Re: Indian Point Unit 3  
Docket 50-286

NL-07-008

**SUBJECT: Proposed Changes to Indian Point 3 Technical Specifications  
Regarding Updated Pressure-Temperature and  
Low Temperature Overpressure Protection System Limits**

## MARKUP OF TECHNICAL SPECIFICATION PAGES FOR PROPOSED CHANGES REGARDING PRESSURE-TEMPERATURE AND LOW TEMPERATURE OVERPRESSURE PROTECTION SYSTEM LIMITS

Figure 3.4.3-1:  
Heatup Limitations for Reactor Coolant System

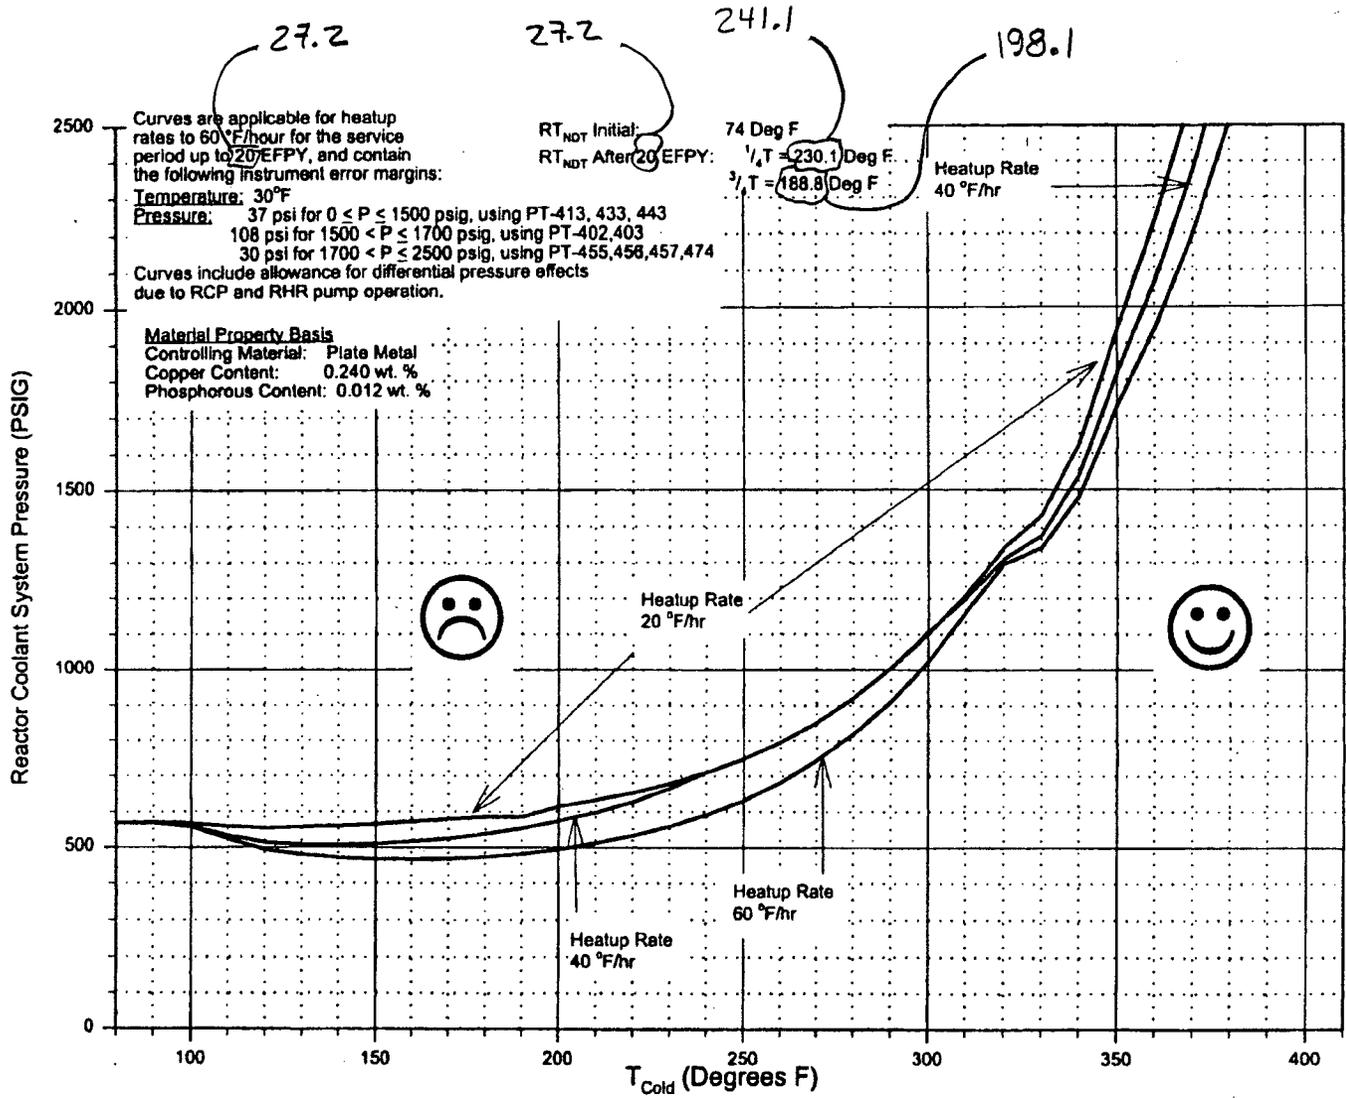
- Revise the expiration limit from 20 Effective Full Power Years (EFPY) to 27.2 EFPY for the three Pressure / Temperature (P/T) Limit graphs in Technical Specification Section 3.4.3 and the four Low Temperature Overpressure Protection (LTOP) graphs in Technical Specification Section 3.4.12.

- Revise the adjusted reference temperature (ART) for the reactor pressure vessel to reflect the above revised expiration limit. The ART at the  $\frac{1}{4}$  T location is changed from 230.1<sup>o</sup>F to 241.1<sup>o</sup>F and the ART for the  $\frac{3}{4}$  T location is changed from 188.8<sup>o</sup>F to 198.1<sup>o</sup>F.

Figure 3.4.12-1: Maximum Allowable Nominal PORV Setpoint for LTOP (OPS), 20 EFPY

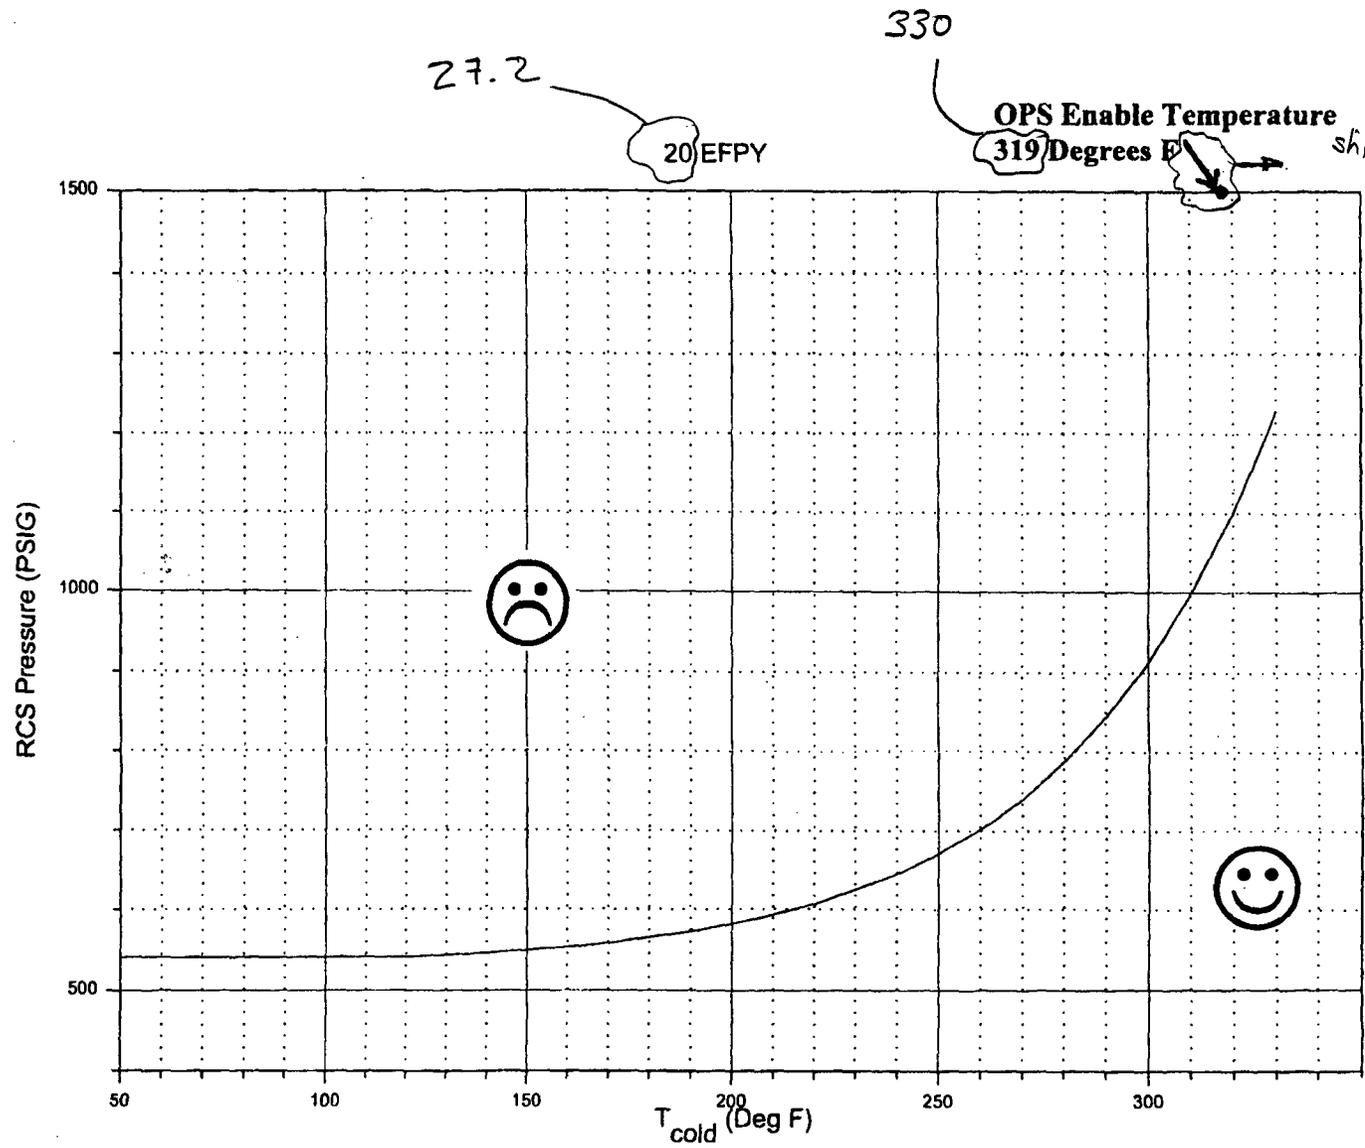
- Revise the Low Temperature Overpressure Protection (LTOP) system arming temperature specified in Technical Specifications 3.4.7, 3.4.10, and 3.4.12 from 319<sup>o</sup>F to 330<sup>o</sup>F. In addition, editorial changes are proposed to make the use of inequality signs consistent among Sections 3.4.7, 3.4.10, and 3.4.12.

INDIAN POINT 3  
3.4.12-9  
27.2  
Amendment 220
